STATE OF CALIFORNIA
STATE WATER RESOURCES CONTROL BOARD

In the Matter of the Petitions)
of CONTRA COSTA COUNTY SANITATION)
DISTRICT NO. 7-A for Review of)
Final Decisions of the Division)
of Water Quality Regarding Grant)
Eligibility. Our Files Nos. G-45,)
G-50, G-51 and G-52.)

Order No. WQG 80-10

RELATIONSHIP BETWEEN DIGESTION DETENTION TIMES
AND METHANE PRODUCTION AT VARIOUS DIGESTION TEMPERATURES

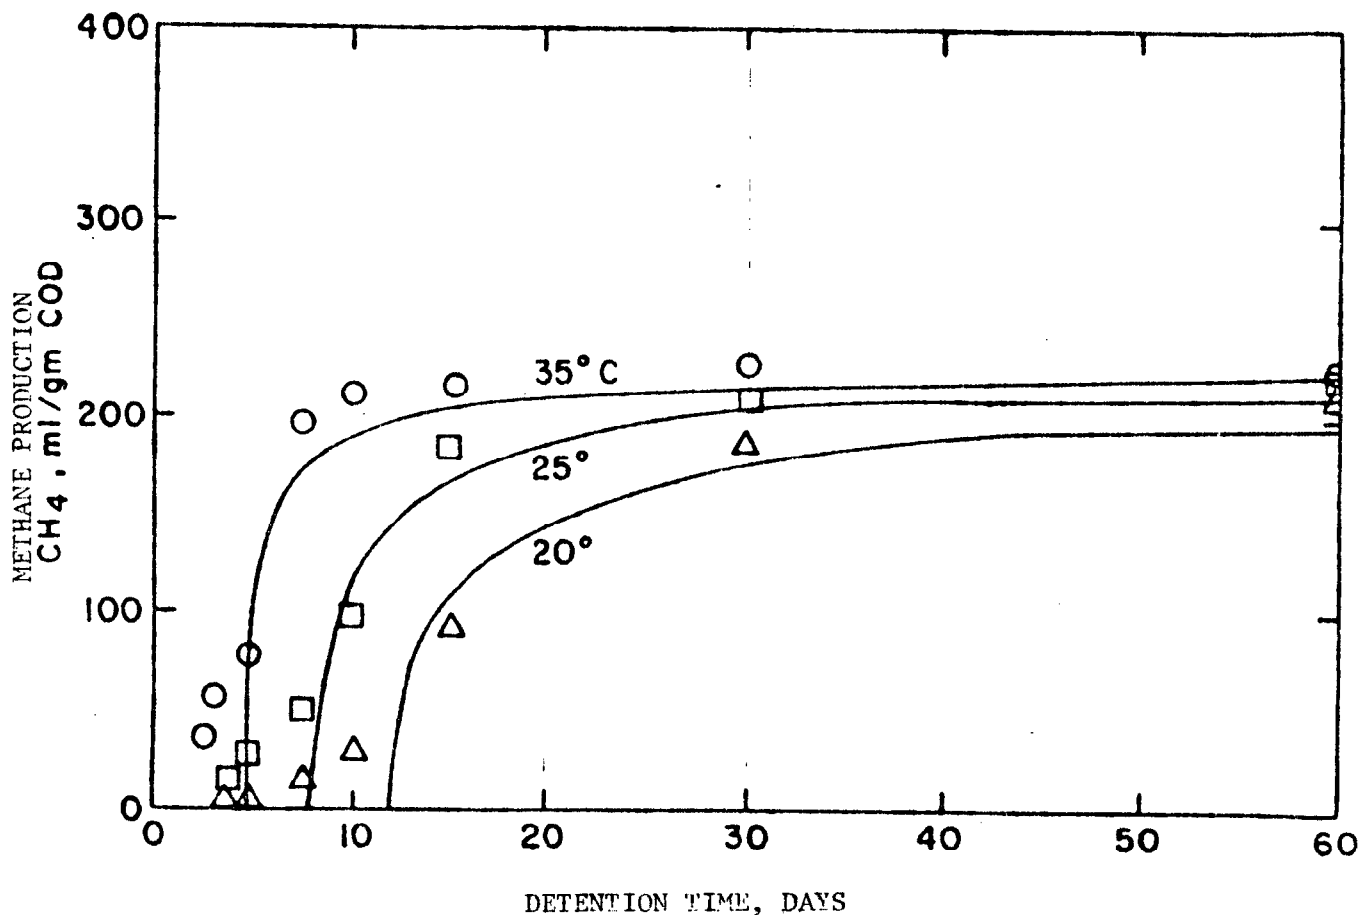
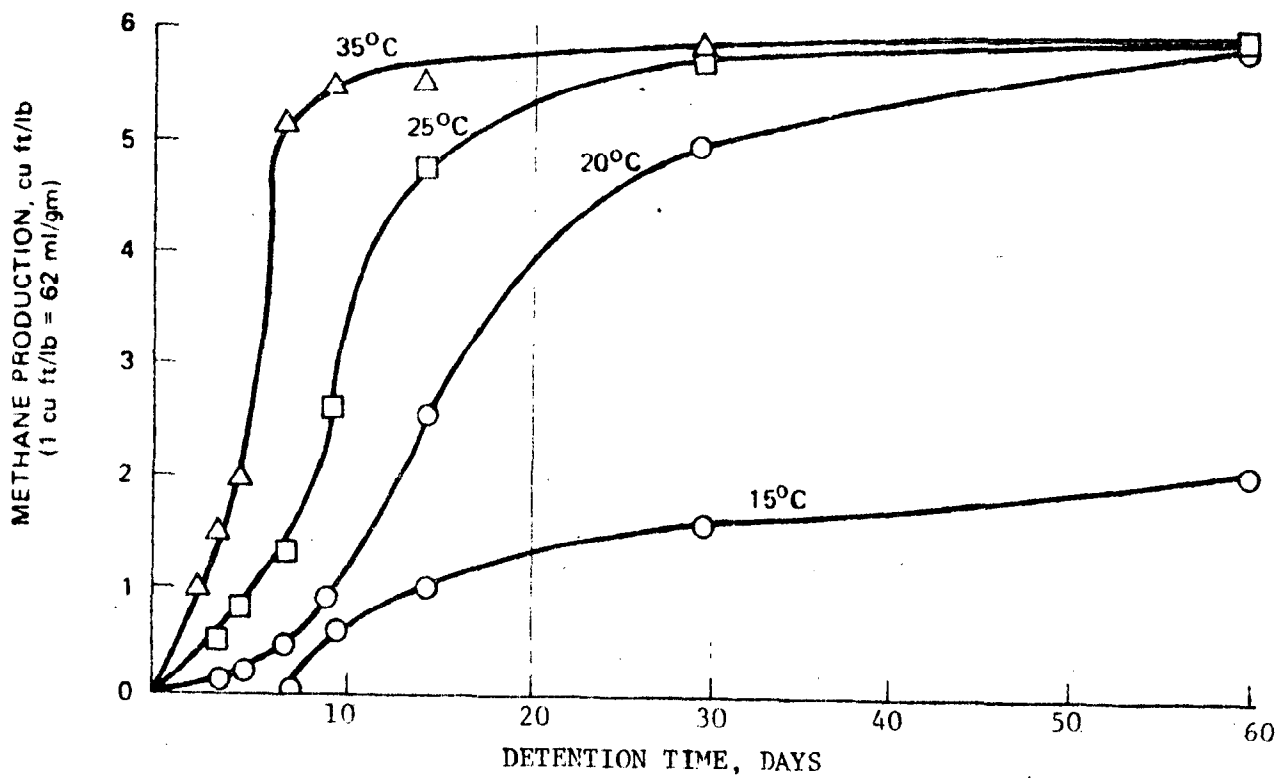
The problem in this case is that we are not convinced that increase of the digester detention time from 20 days to 30 days will significantly increase the total methane gas production. As a matter of fact, increase of digester detention time from 20 days to 30 days will not significantly increase the total methane gas production. After 15 days detention time, there is no appreciable increase in the methane gas production due to further digester detention at 35°C, the temperature for which the District's digesters are designed. (See attached graphs.)

Accordingly, we find that the larger digester sizing proposed by the District is not more cost effective than the digester sizing determined to be grant eligible by the Division due to alleged increase of methane gas production.
